AGENDA

Design Review Committee

December 13, 2023 – REGULAR MEETING

Town of Jackson Design Guidelines Checklist

MOJAVE THERMO DOUG FIR VG SMOOTH

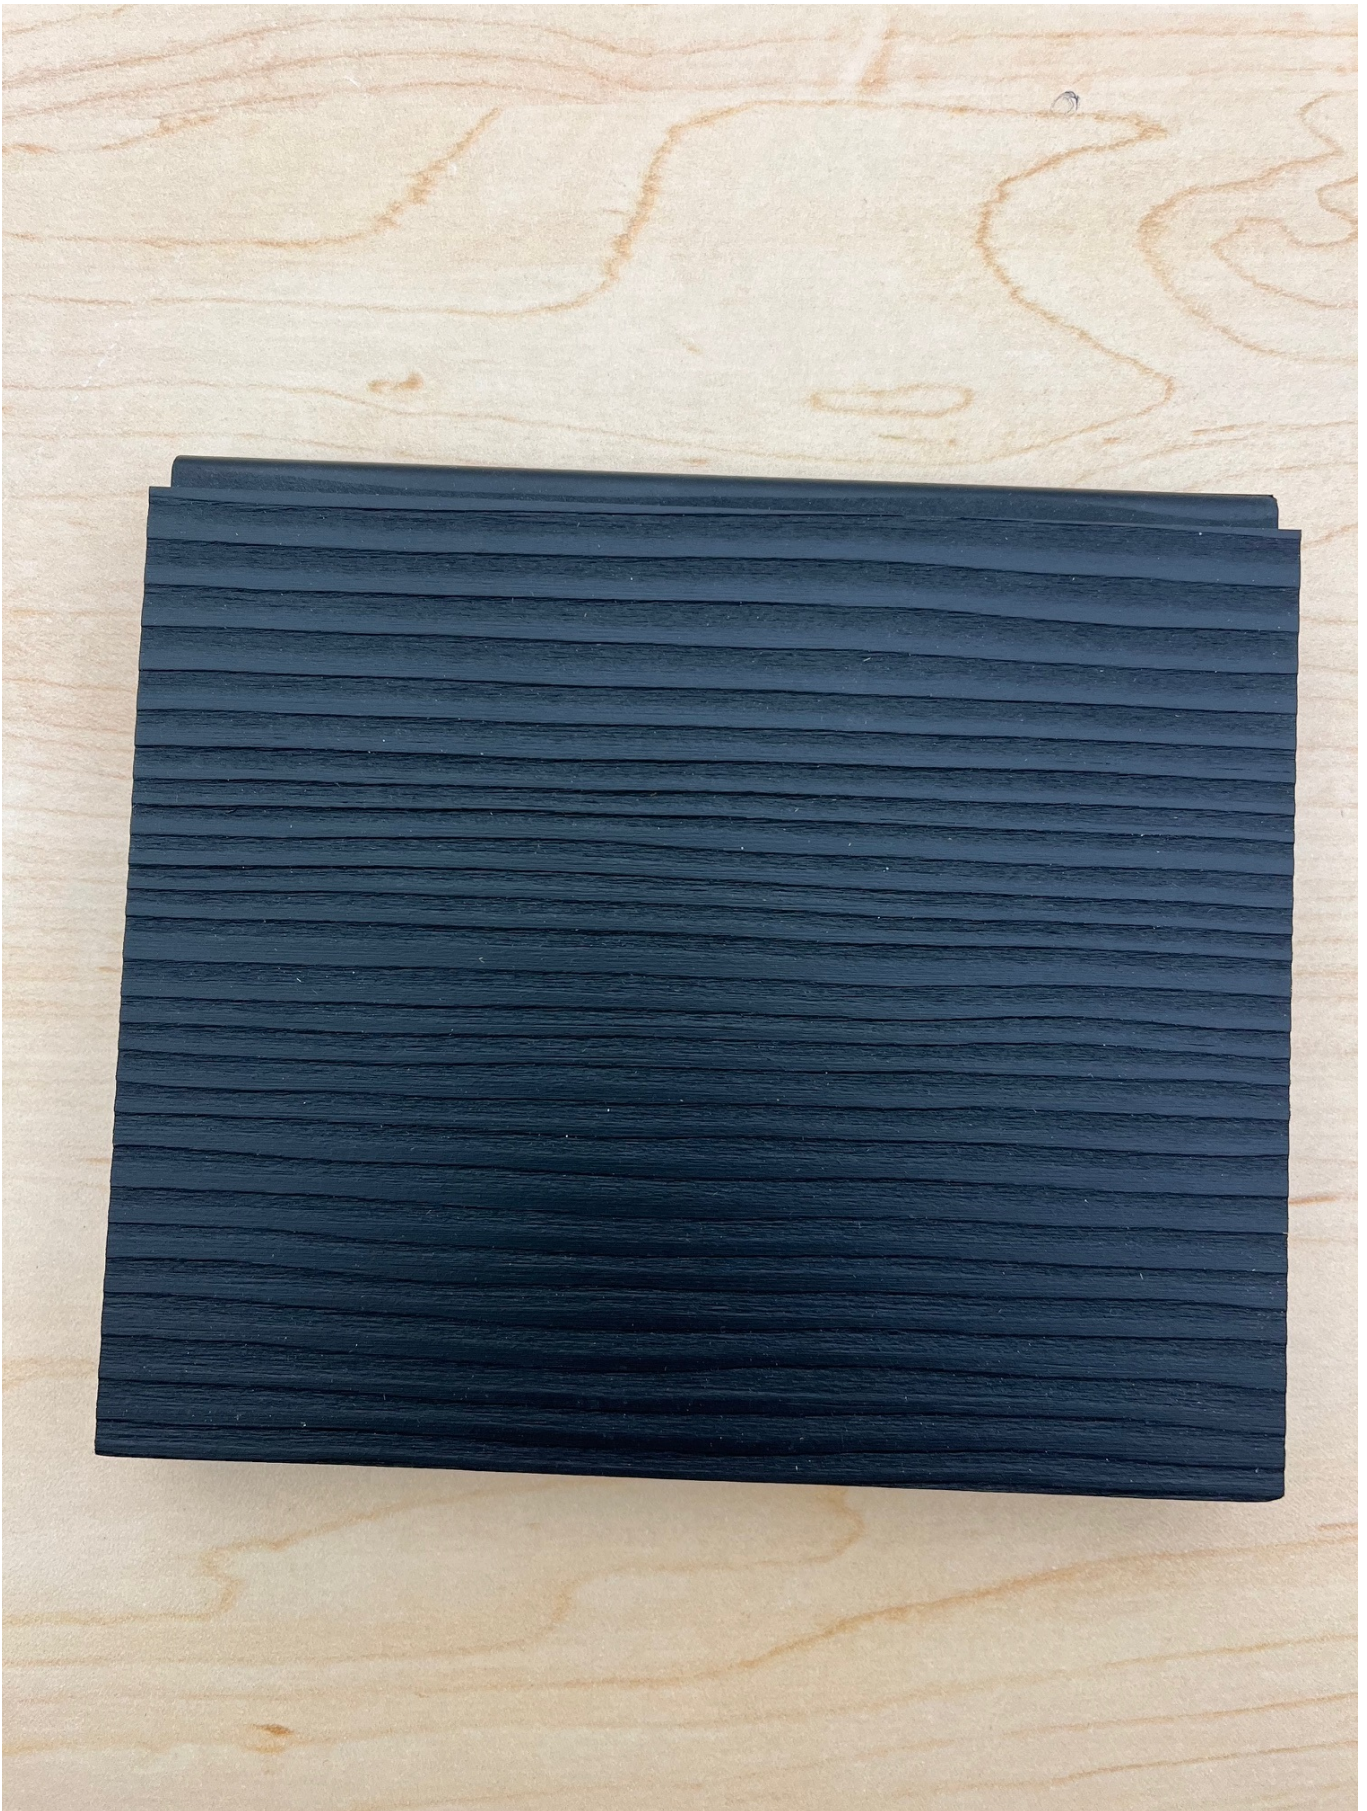
1. Prior to building permit submittal, the applicant shall submit the final charred wood material for DRC review.

Project Summary: The applicant is seeking a final review of the final charred wood material sample. As proposed, the final material is Mojave Thermo Doug Fir VG Smooth - Delta Black (see photos below). No changes to the building are proposed. Below under the material sample photos is a summary of the approved project.

② West Elevation Color
1/8" = 1'-0"

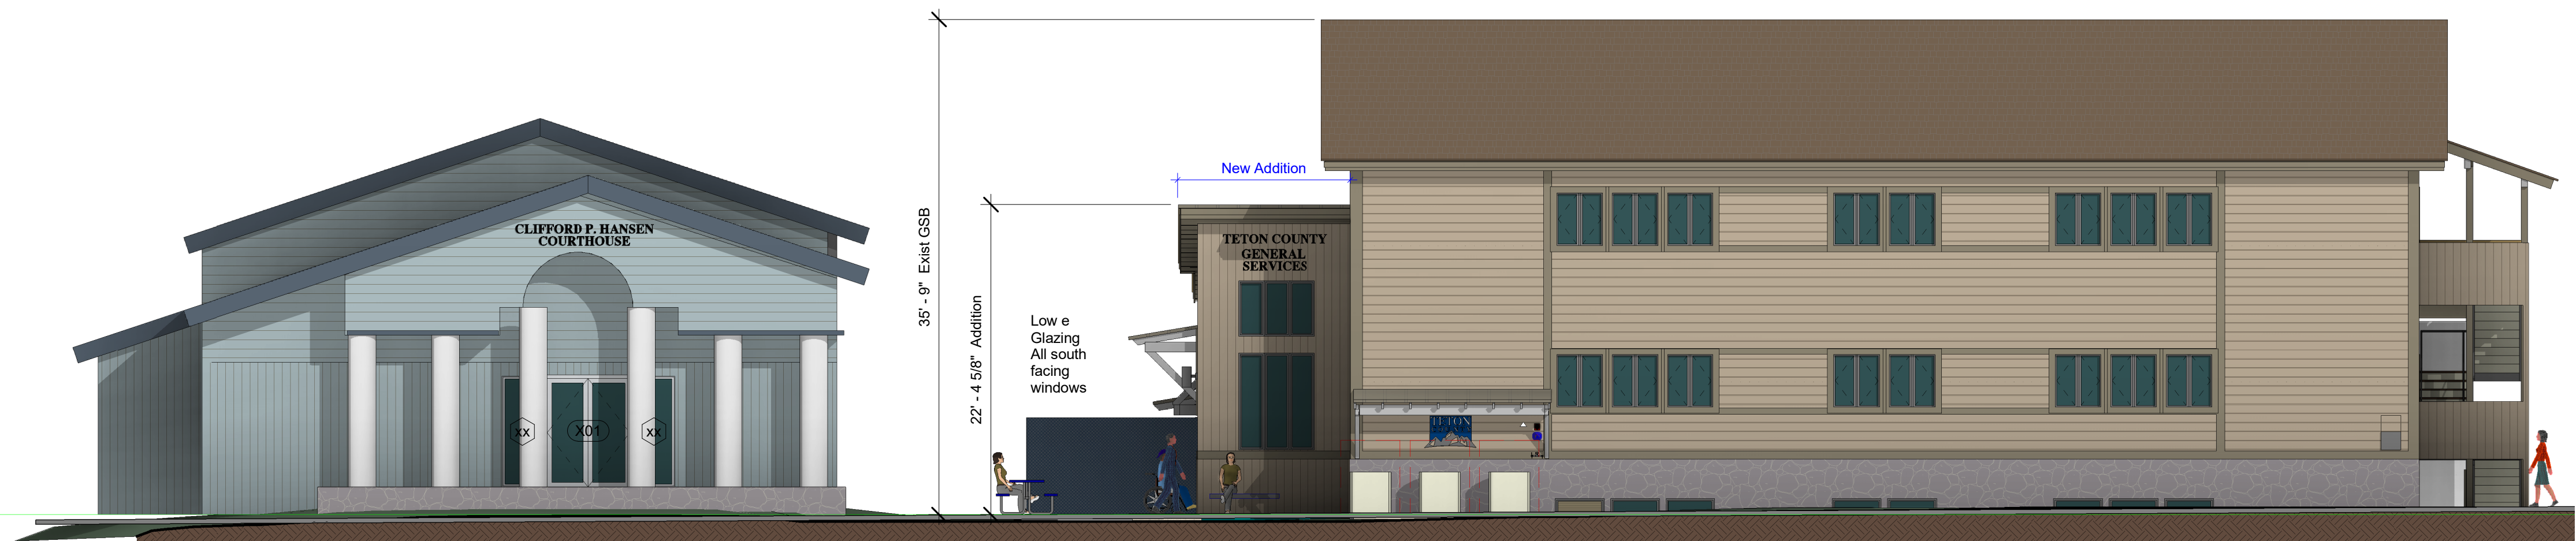
- Create more prominence for western entry;
- Combine screening for the eastern stair and the utility component so they read as one screening element; and
- Consider ways to make the eastern façade along S. Willow seem less “back of house”.

Since our last review in October of 2023, we added canopies to both entries on the West side of the new addition – one scaled higher for typical pedestrians meant to attract focus from the street, the other scaled lower for wheel chairs. We also revised the windows of the entry pavilion to be much taller, to differentiate them from the primary building, while maintaining a visual reference to the dyptic style windows of the existing rooms. A need for shear strength without making a leap to steel moment frames limited these windows to punched openings. We also added a roof to protect the heat pumps so that they could move to the south (Simpson) side and not distract from the landscaped entry sequence. The east façade along Willow Street features a siding-clad egress stair shroud which is folded and carved to shield mechanical equipment and to allow natural light. A window was added in the vehicle bay to appear friendlier. Minor revisions include the elimination of concertina wire above the north wall facing the jail yard, spacing of north windows in the office area, and a chosen accent color for the LP smart side trim boards. Thank you for looking at this project one more time.

Site design, parking, and ground floor plan

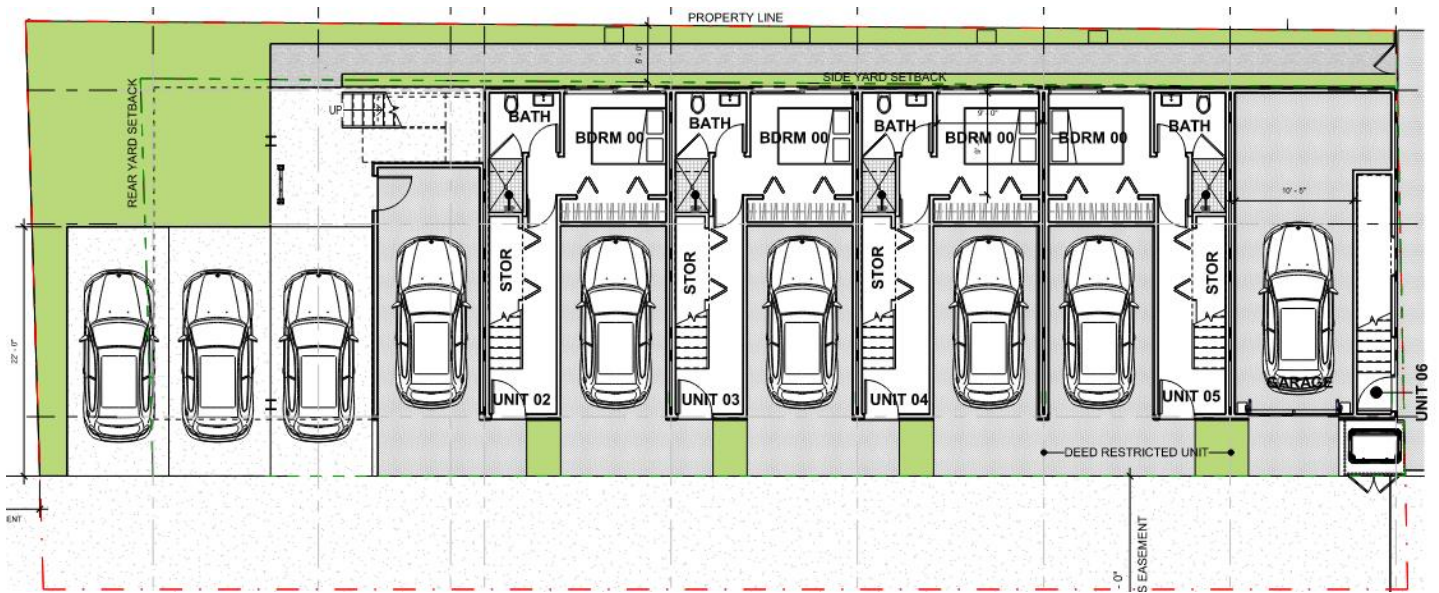
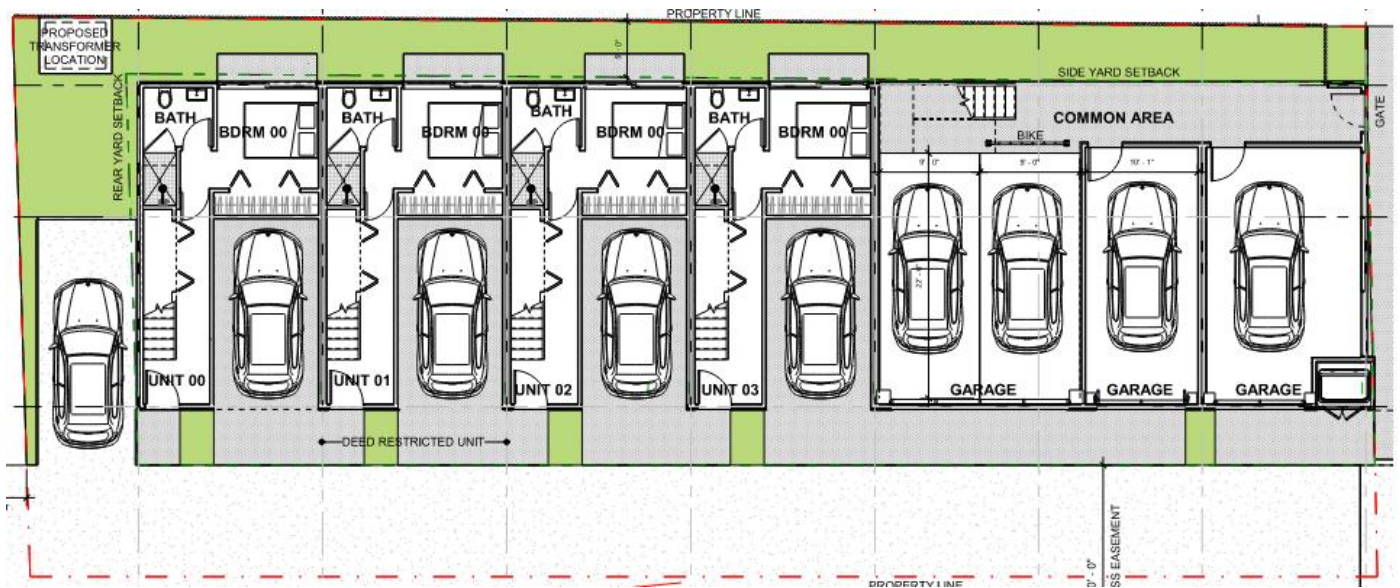
- Consider how snow fall can be mitigated in roof design;
- Consider roof drainage, particularly near rear parking area;
- Garbage location is directly under a residential deck. Not ideal for resident; and
- Address general site plan "fixes" such as parking screening, dumpster location, etc.

Staff has concerns over adequacy of proposed snow storage shown in small landscape strips adjacent to parking stalls. Plant units are also proposed for this area and snow may block parking stalls over the course of a winter season. Alternate locations for potential snow storage do not appear practical as they are blocked by fencing or vehicle parking spaces. It is possible the building program may be required to remove a vehicle parking space for final building permit to provide practical snow storage. While this has the potential to impact total unit count, staff does not feel the change would substantially change building design in terms of DRC review.

- Reconfigured floor plan and exterior stair access.
- Reconfigured parking plan in rear of structure
- Extended structure west where surface parking was previously located.

- Removed landscape path along northern boundary.
- Increased transparency at ground level street façade.
- Fully screened parking within the required parking setback from N. Glenwood St.
- Screened trash enclosure from N. Glenwood Street and met required setback from shared access drive.
- Exchanged street trees for aspen rather than spruce (staff notes they are shown in error on site plan 0.0 as Blue Spruce)

- Structure setback – The applicant shows the structure meeting required setbacks in the CR-2 zone.
- Parking setback and screening – The applicant has revised site and building floor plan to fully screen parking within the 30' parking setback as measured from the back of pedestrian frontage.
- Plant Units – Applicant has updated landscape plan to show compliance with required plant units.
- Landscape Surface Ratio (LSR) – Applicant has updated landscape plan to show compliance with required LSR.
- Trash and Recycling Enclosures – Applicant has updated site plan to screen trash and recycling enclosure.
